REPLACE ROOF CIVIC CENTER

FRANKFORT, KENTUCKY

"AS-BUILT" NOTE: 25 July 2005

REPLACE ROOF -- CIVIC CENTER FRANKFORT, KENTUCKY		DRAWING NO. A-1
AS BUILT DATE 25 JULY 2005	ROOF PLAN	
DRAWN BY <i>MARTIN</i>	COMMONWEALTH OF KENTUCKY FINANCE AND ADMINISTRATION CABINET DEPARTMENT FOR FACILITIES MANAGEMENT DIVISION OF ENGINEERING FRANKFORT, KENTUCKY	
CHECKED BY <i>MARTIN</i>	WILLIAM C. MARTIN, P.S.C. ARCHITECTS-ENGINEERS 620 EUCLID AVENUE LEXINGTON, KENTUCKY	
A & B FILE 573-75	REVISED BY DATE 18 Nov. 2003	
AGENCY AUTHORIZED AGENT	APPROVED FOR PROGRAM CONCEPT ONLY DATE	
DIVISION OF ENGINEERING	APPROVED FOR PROGRAM CONCEPT ONLY DATE

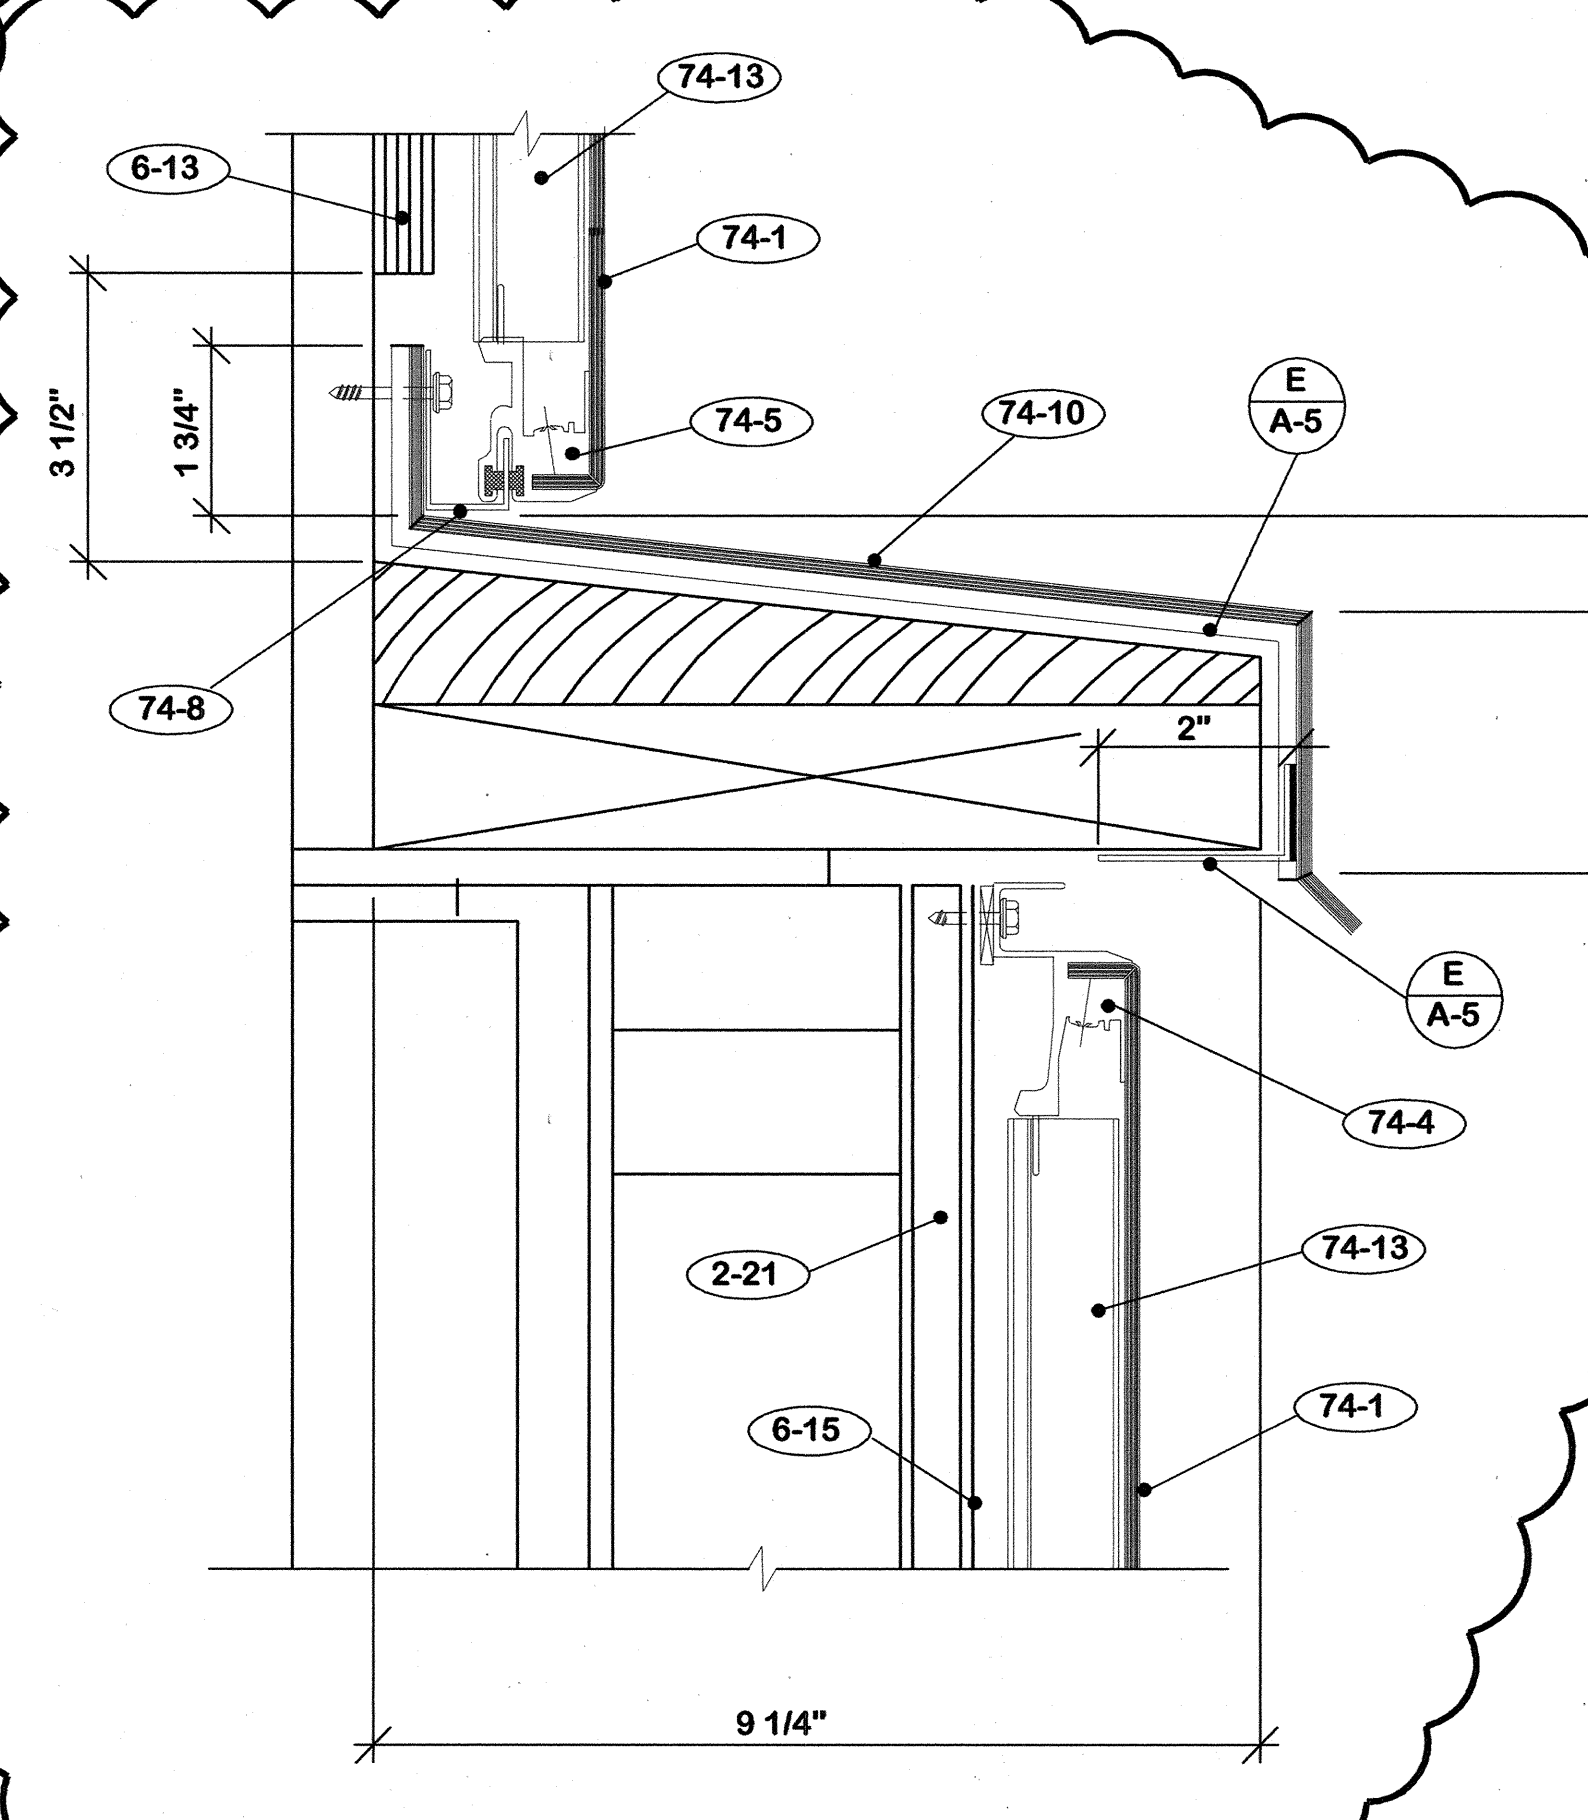
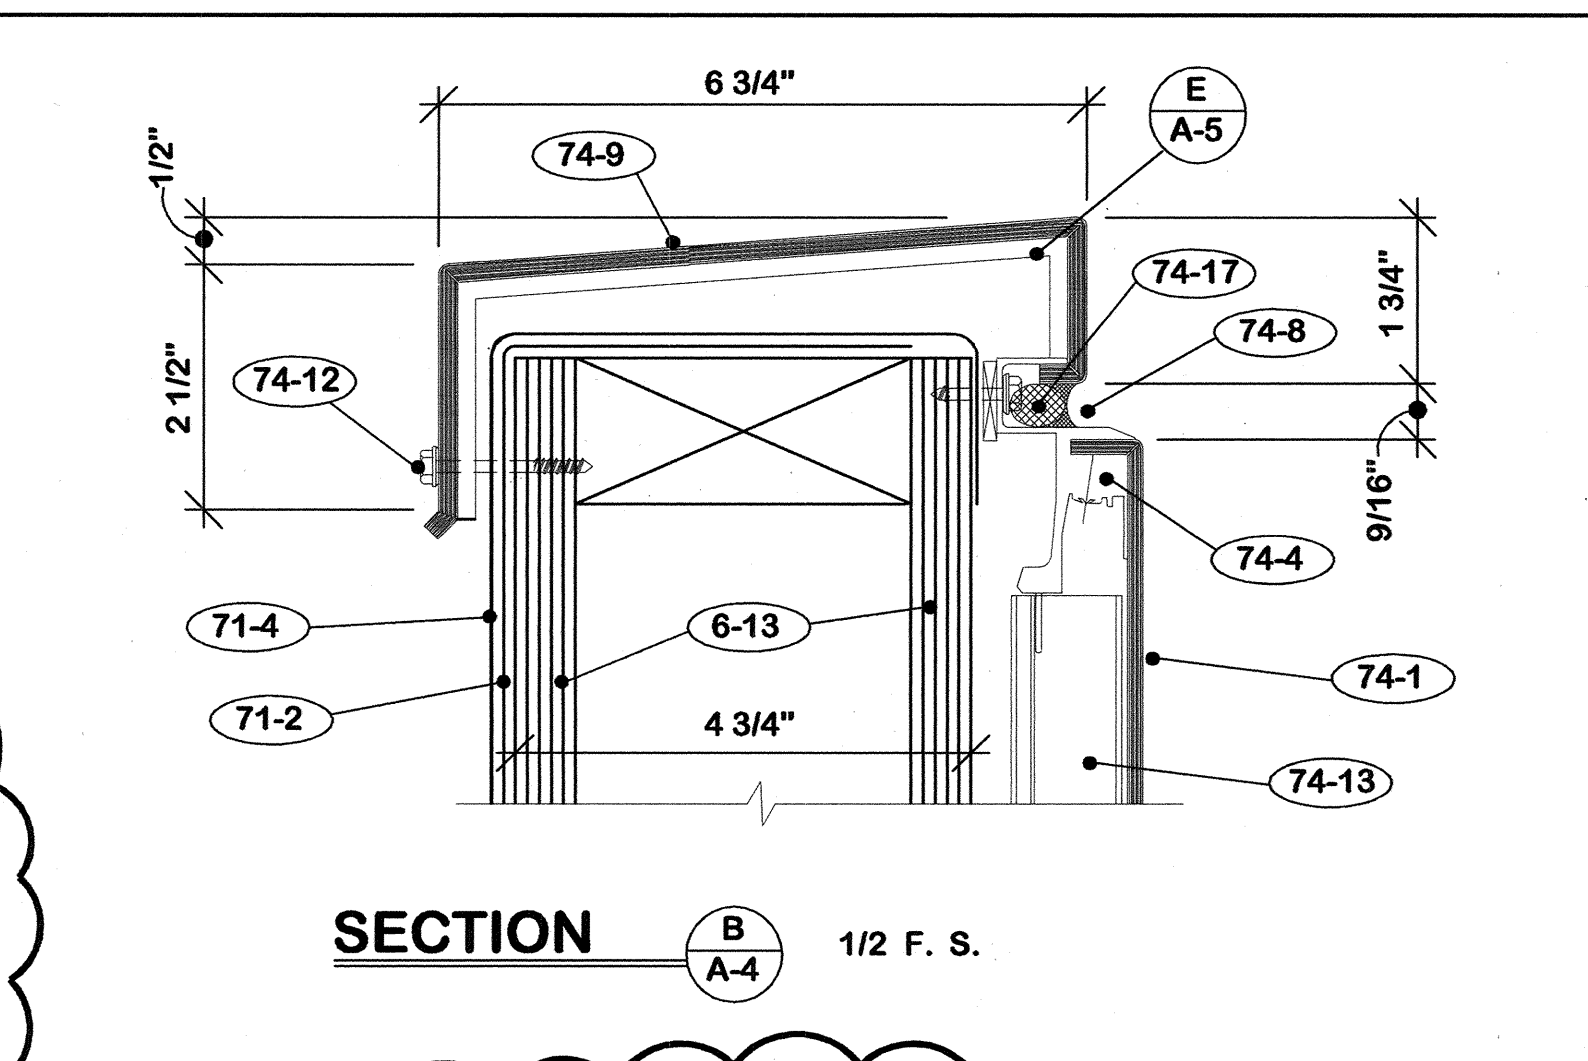
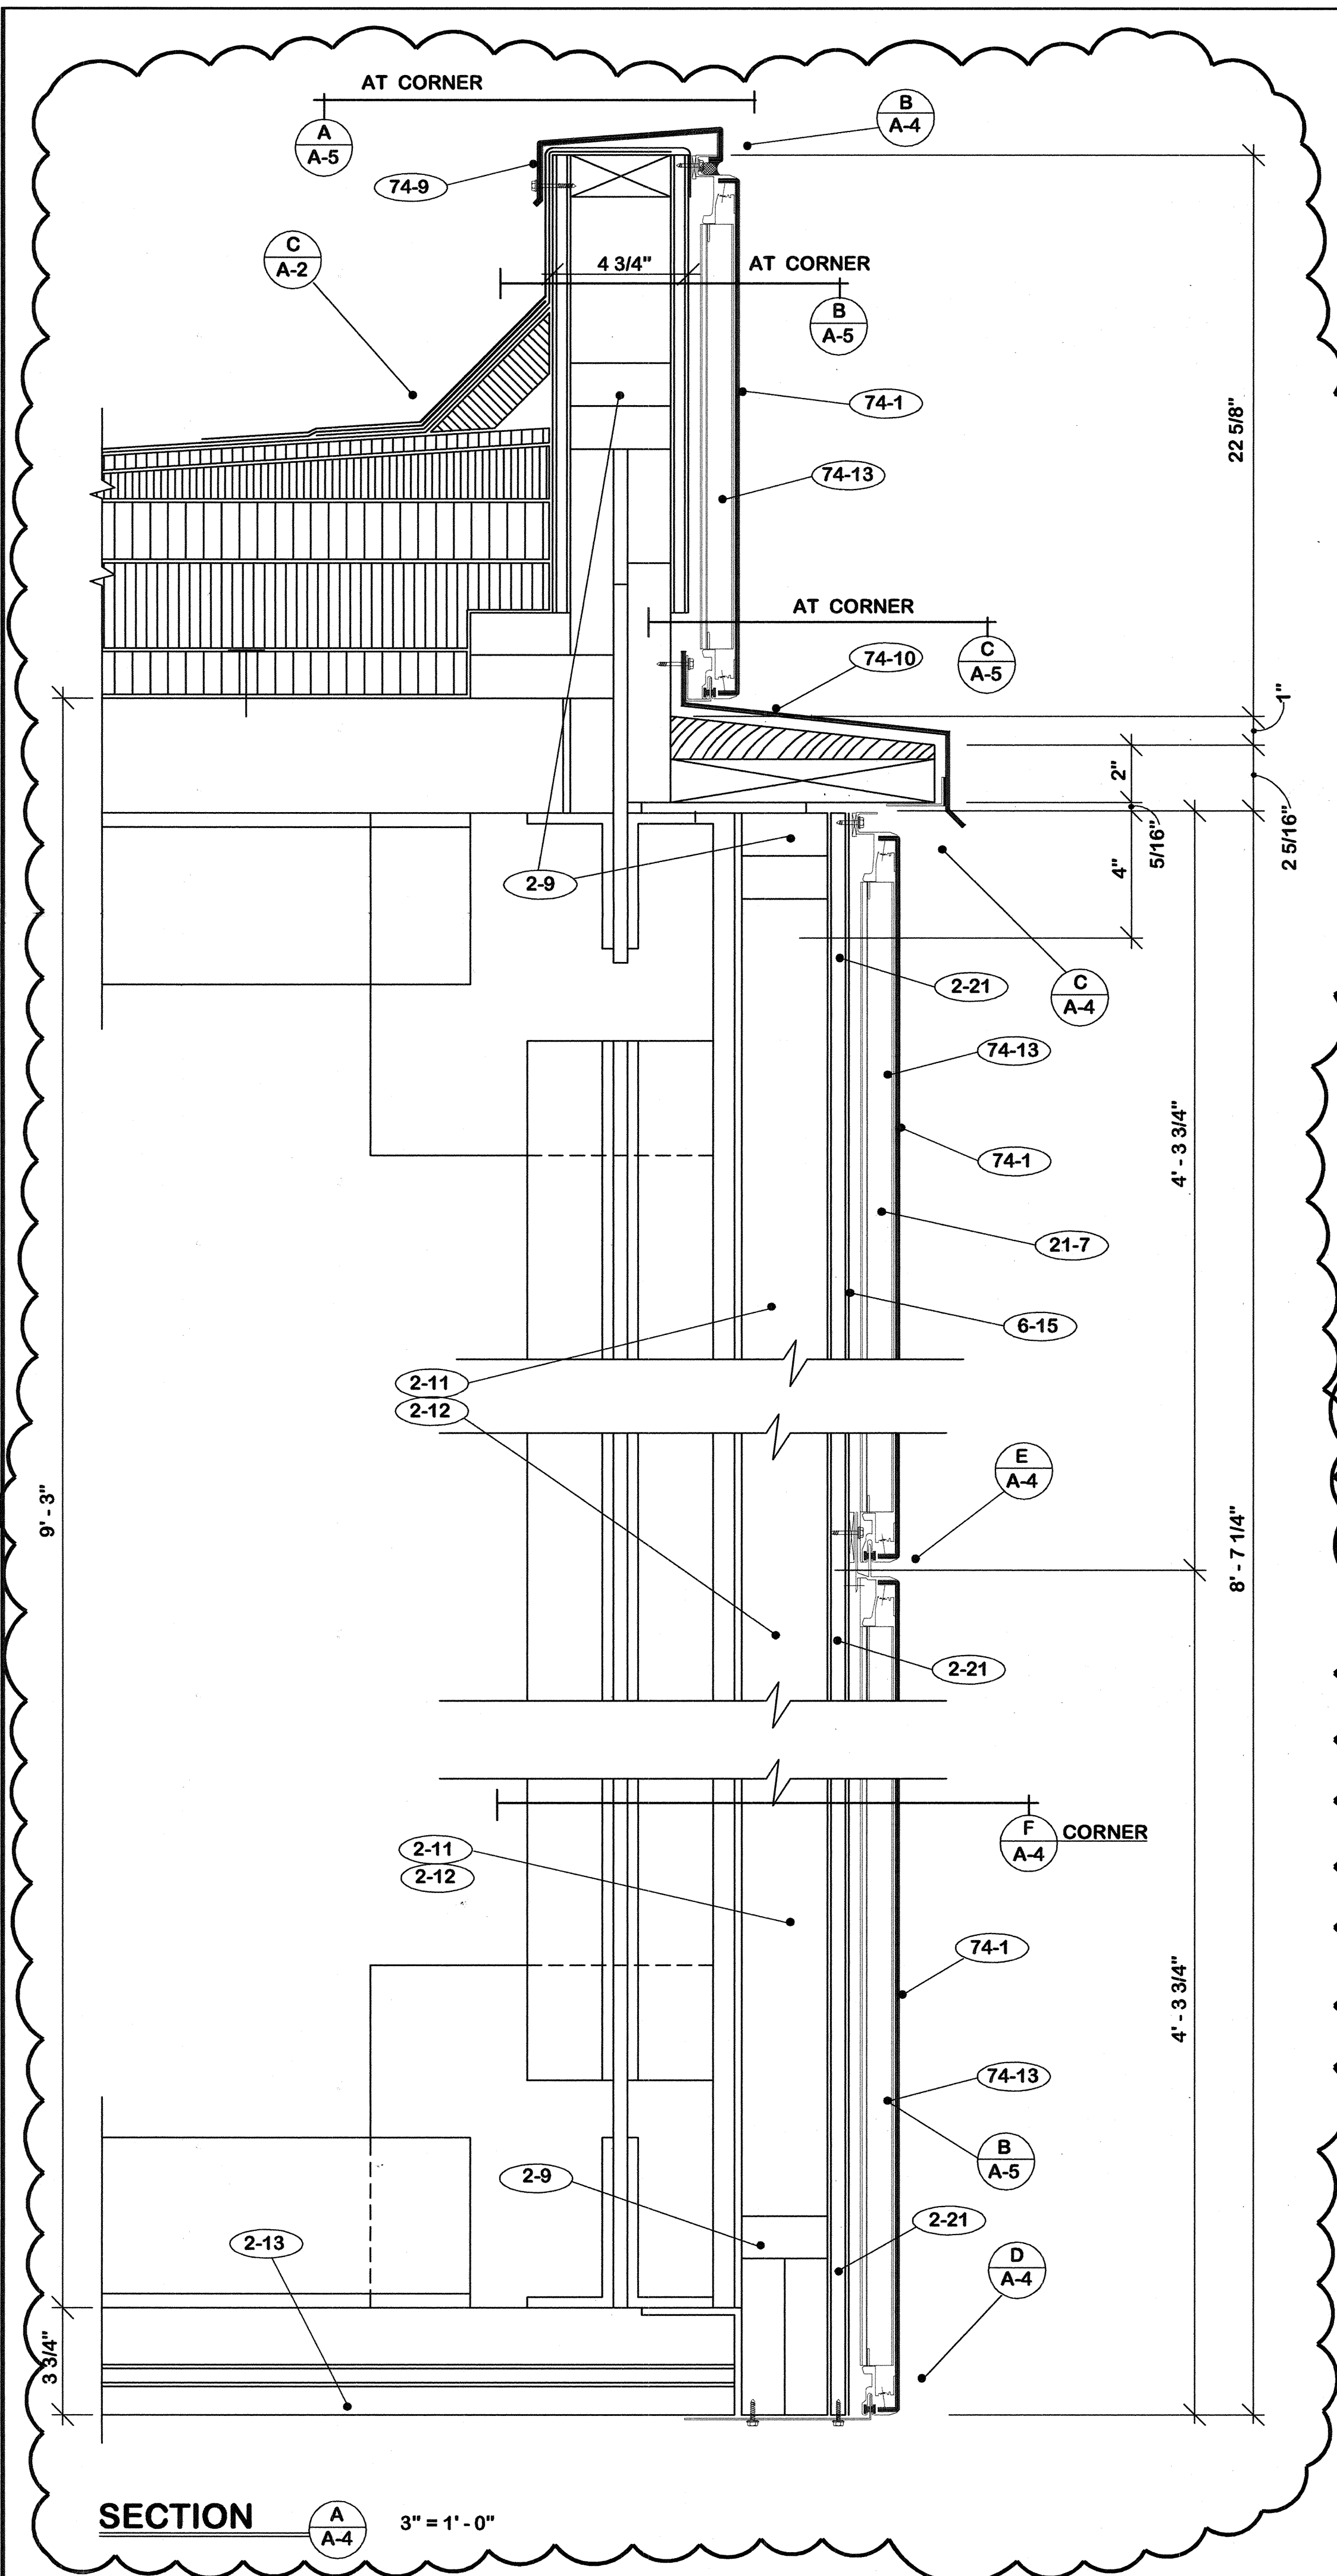
"AS-BUILT" NOTE:

1. Revised details to show 1/2" existing plywood was left in place.
2. Delete note 6-14.
3. Delete note 21-6.
4. Add note 2-21.
5. Change total number drawings to 12.

DETAIL D-A-5 1/2 F. S.

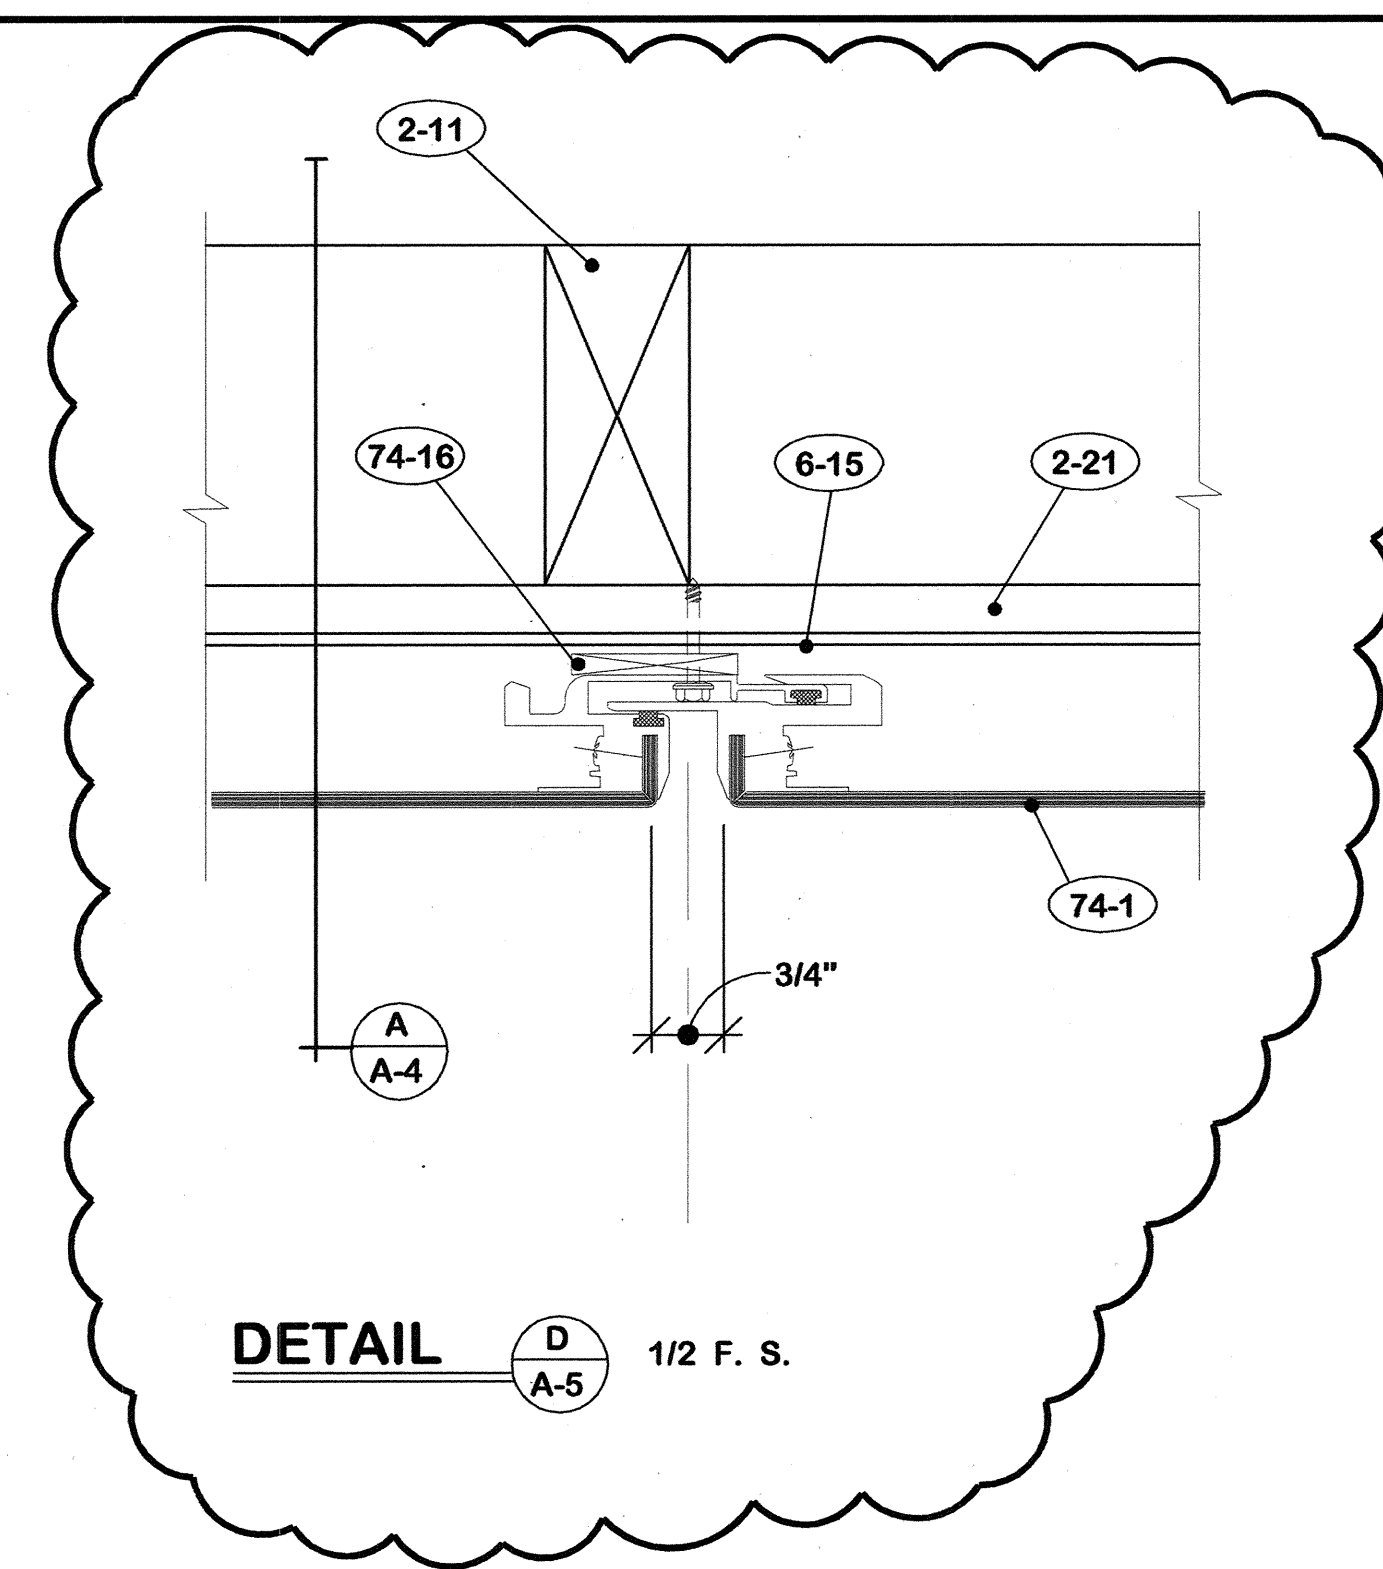
1. Revised detail D/A-5 to show 1/2" existing plywood was left in place. Changed note 6-14 to 2-21.
2. Added details G/A-5 and H/A-5. Vent shaft roof details.
3. Changed total number of drawings to 12.
